From: "DAVANT, GUY H" <GDAVANT@entergy.com>
To: "twa@nrc.gov" <twa@nrc.gov>
Date: 4/28/04 4:31PM
Subject: Revised Information Package Supporting Relief Request ANO1-R&R-006

Response to NRC Questions

Figure 6— Results of EPFM Stability Analysis for ANO-1 Top Head Remnant Cracking Concern

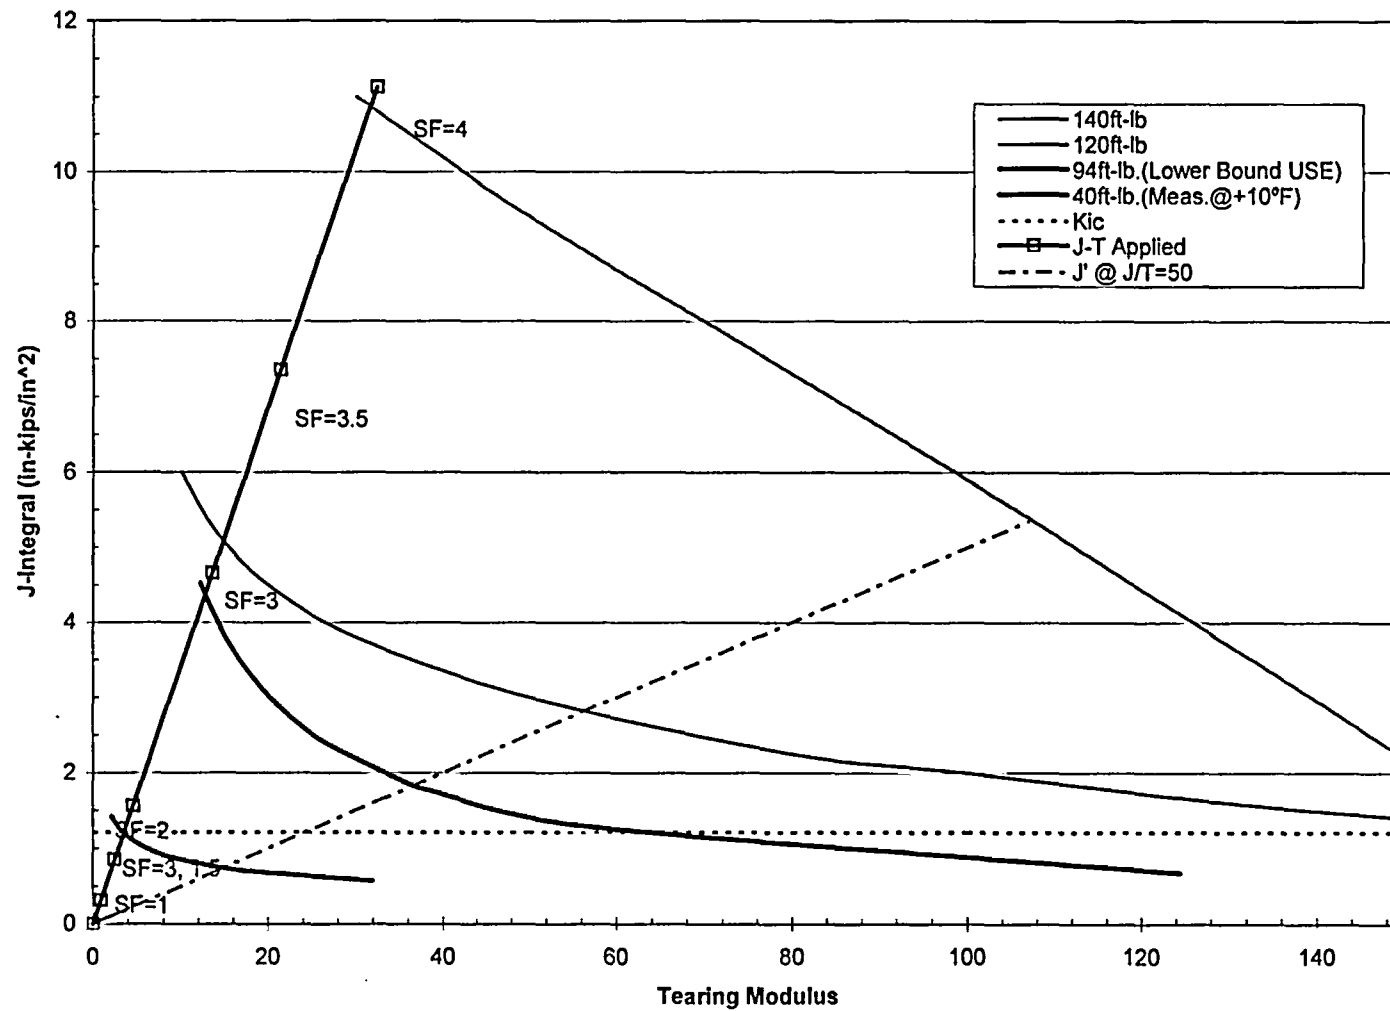
In addition to the revised Table 1 and Figure 6, our response to NRC Question 4 (discussed in yesterday's call) also changes. As I mentioned in my previous e-mail, the 94 ft-lb curve no longer meets $SF = 3$ for both primary and secondary stresses. We have revised our response to Question 4 to reflect this change, as reflected in the attached file. For convenience, I am providing a complete, revised package of information. This package replaces the package I sent to you yesterday. This information may be docketed.

4. The analysis demonstrates large margins between applied J-integral and the crack instability point (i.e. the point where the applied J-T line intersects the appropriate J-T material curve) in all cases. In Figure 6, it is seen that the applied J-T point for the recommended safety factors of 3 on primary loads and 1.5 on secondary (residual) loads is below even the 40 ft-lb J-T material curve, which was measured at +10 for the ANO-1 head material, and is an extreme lower bound of USE for this material. Considering a more reasonable estimate of J-T material for the ANO-head material on the upper shelf (the 94 ft-lb curve – still a lower bound) shows ample margin to instability.
